**TOWN OF HARVARD
PLANNING BOARD AGENDA
MONDAY, JANUARY 22, 2024 @ 7:00PM Revised**

**RE: 184 Ayer Road
Stormwater Site Plan Review
Harvard, MA**

Reference: Supplemental Peer Review -Stormwater Site Plan
184 Ayer Road
Harvard, Massachusetts
B+T Project No. 3241.05

SHEET NO. **C4.0**

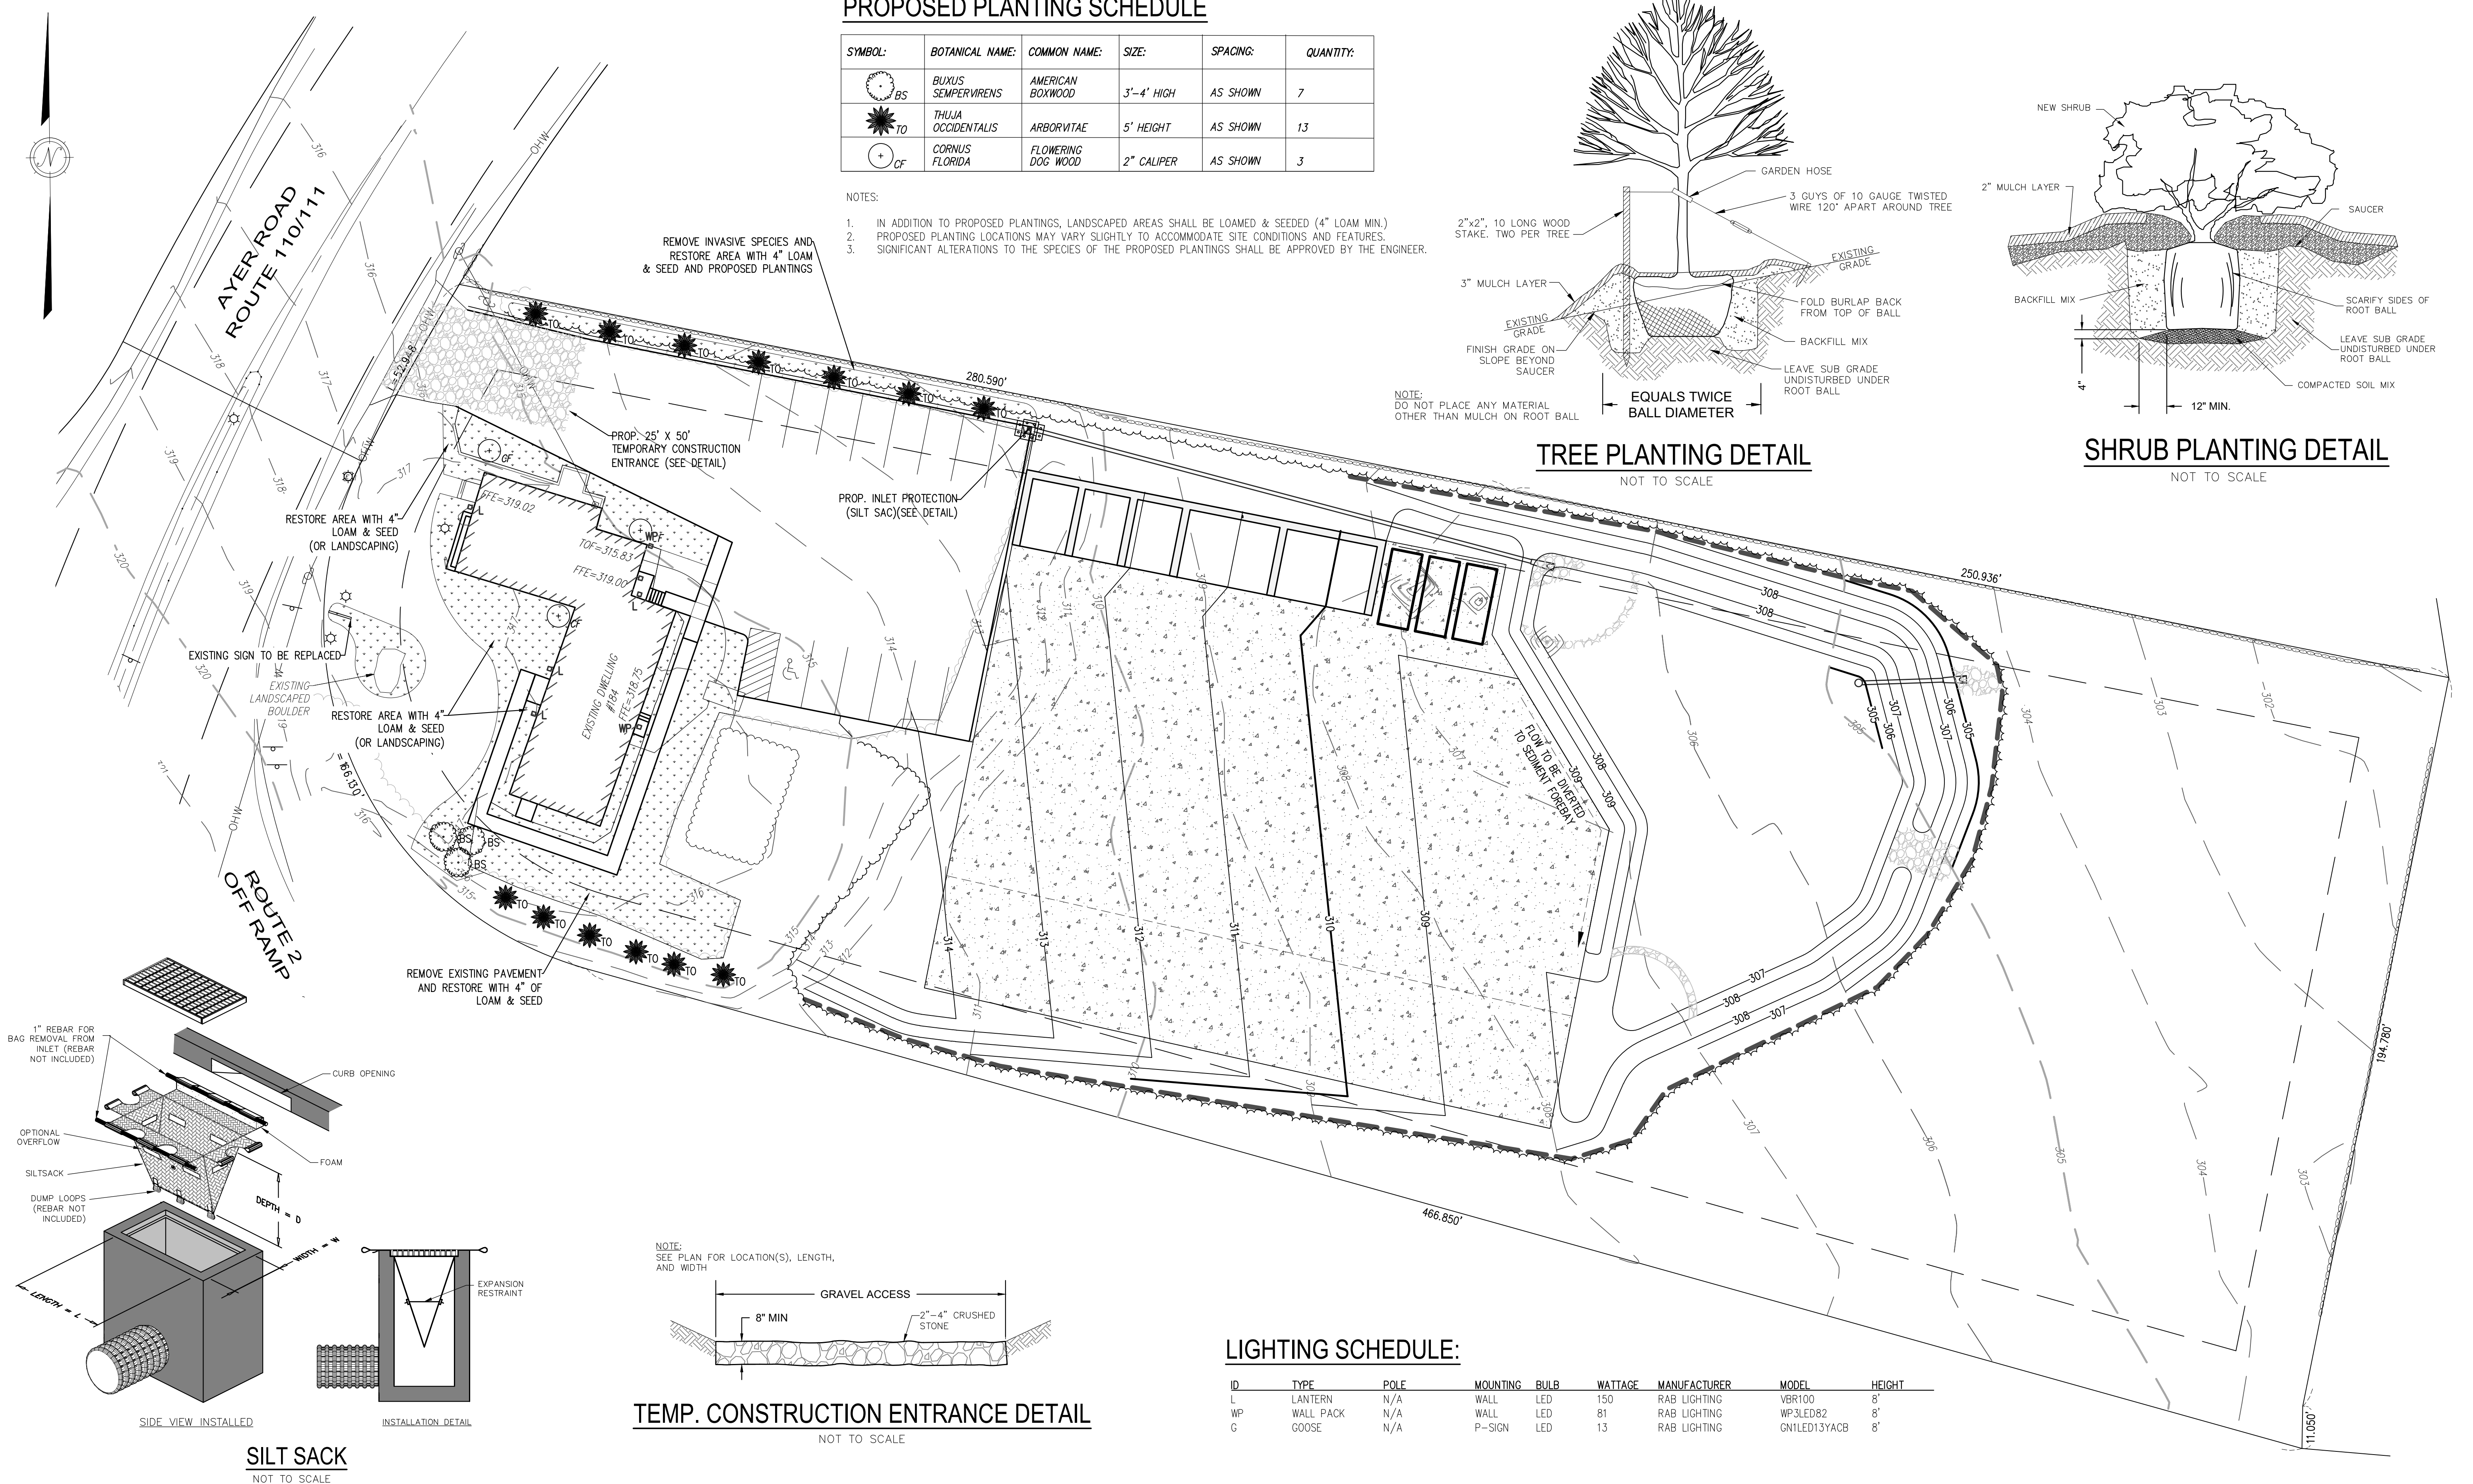
3. *Standard 8 of the Handbook requires a construction period pollution plan. Disrupting more than 1 acre, the Project will also need to file an EPA NPDES Construction General Permit with a Stormwater Water Pollution Prevention Plan (SWPPP). The Applicant had not provided construction period controls; however, intends to use the SWPPP to satisfy this requirement. The Applicant has not provided a SWPPP but intends to do so prior to construction. As a potential condition of approval, we recommend that the Applicant submit a fully compliant SWPPP prior to construction for Board review. In the meantime, we request that the Applicant update the site plan submission to include details and provisions for catch basin silt sack protections and a stabilized construction exit.*

3. Standard 8 of the Handbook requires a construction period pollution plan. Disrupting more than 1 acre, the Project will also need to file an EPA NPDES Construction General Permit with a Stormwater Water Pollution Prevention Plan (SWPPP). The Applicant had not provided construction period controls; however, intends to use the SWPPP to satisfy this requirement. The Applicant has not provided a SWPPP but intends to do so prior to construction. As a potential condition of approval, we recommend that the Applicant submit a fully compliant SWPPP prior to construction for Board review. In the meantime, we request that the Applicant update the site plan submission to include details and provisions for catch basin silt sack protections and a stabilized construction exit.

D&R – Plan Sheet C4.0 has been revised to include the above-mentioned soil erosion & sedimentation control provisions. The applicant does not object to a condition requiring the submittal of the SWPPP once it is prepared.

Applicant's Response: Plan Sheet C4.0 has been revised to include the above-mentioned soil erosion & sedimentation control provisions. The applicant does not object to a condition requiring the submittal of the SWPPP once it is prepared.

B+T Response: We acknowledge the revisions provided to Sheet C4.0 and consider that portion of the comment adequately addressed. We reiterate the intent of our initial comment relative to the noted recommended condition of approval for consideration by the Board.
